Title: <u>Application for Departure from Standard (DfS)</u>	Issue: V1 SEPT 2023
--	--	--------------------------------------

Scheme Title:	M65 Terminus
Location:	M65 Terminus, Preston PR5 6BD
Design Specialism:	Highways

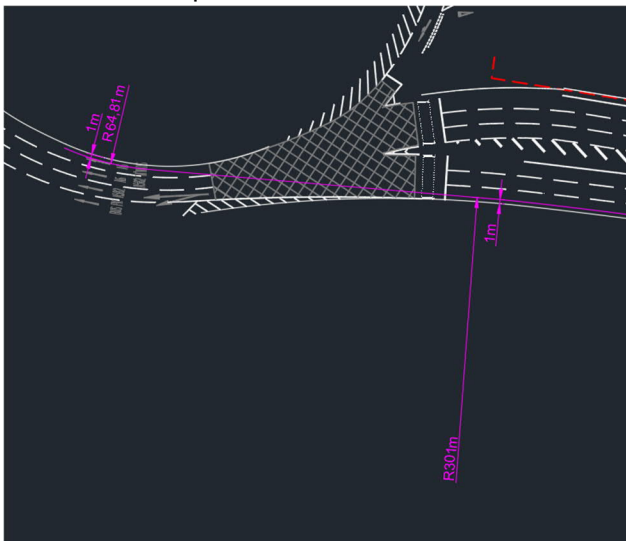
The screenshot below shows the entry path radius of the proposed approach to be 301m. This does not meet the requirements set out in Clause 3.26 and therefore a departure is required.

<i>Difference between standard and proposed design:</i>	<p>The proposed design is shown on drawing 84465-WSP-XX-DR-0004 P07.</p> <p>There is a site boundary of the existing DVSA site to the north of the scheme providing a physical constraint that cannot be adjusted.</p> <p>This limits the space available for the M65 approach which we have positioned as close as reasonably practicable to the existing site boundary.</p> <p>This in turn further constrains the M6 approach due to the offsets required to safely separate the two approaches leaving enough room for gantry foundations/VRS etc. Therefore, the M6 approach must be aligned as shown on the attached drawing which does not comply with the standards.</p> <p>The non-compliance entry path radius could potentially increase vehicle speed when entering the roundabout. This gives road users less time to react when changing lanes or as traffic signals change.</p>

<i>Reason for Departure (overview):</i>	<p>This departure is required to facilitate the M6 approach carriageway onto the roundabout as there is insufficient land available to the north to meet the horizontal alignment requirements set out above.</p> <p>There is no scope to realign both the M6 and the M65 within the existing site constraints.</p>
<i>Associated Project Departures:</i>	<p>Departure 1 – Gantry Mounted Directional Signage</p> <p>The design proposal is to incorporate gantry mounted directional signage on the approach to the M65 terminus roundabout. This does not meet the design criteria defined above as the separated carriageways the gantries would span only have two running lanes. A departure from standard is required for non-compliant gantry mounted signs.</p>
<i>Other options considered:</i>	<p>There is a separate design option of this scheme which consists of a merged approach to the roundabout from the M65 and M6. This omits any confusion as the M6 / M65 traffic merges prior to the roundabout, where it follows the same advanced directional signage.</p> <p>The proposed alternative drawing arrangement is shown on drawing number 84465-WSP-XX-DR-0019 P04.</p> <p>This option is being progressed in parallel to this design option.</p>

<p>do not allow the carriageways to be realigned to meet the required standards.</p> <p>A further reduction in speed limit from 50mph to 40mph is proposed approximately 150m from the stop lines. This is to give road users more time to anticipate and react to the traffic signals.</p> <p>As a result of this the speed limit of the approach has been reduced to 40mph and the junction is to be signalised to further encouraged reduced speed on approach. The signals will be gantry mounted.</p> <p>A stage 1 road safety audit has been received and the comments received related to the scheme's signage and road marking strategy. The addendum to the road safety audit was received 23/07/23 and the design drawing (84465-WSP-XX-DR-004) has been updated to incorporate the safety concerns raised in the audit report.</p>
<i>Congestion/delay</i>	<p>The proposed layout of the M65 terminus has been tested using both LinSig and VISSIM modelling software for the AM and PM peak hours with the proposed development traffic and a future assessment year of 2037.</p> <p>Traffic modelling suggests that with the development traffic and the proposed scheme, there is a forecast queue of approximately 70–110m on each of the separated approaches on the M65 arm (eastern approach), in the AM and approximately 60-70m on the eastern approaches in the PM peak periods.</p>
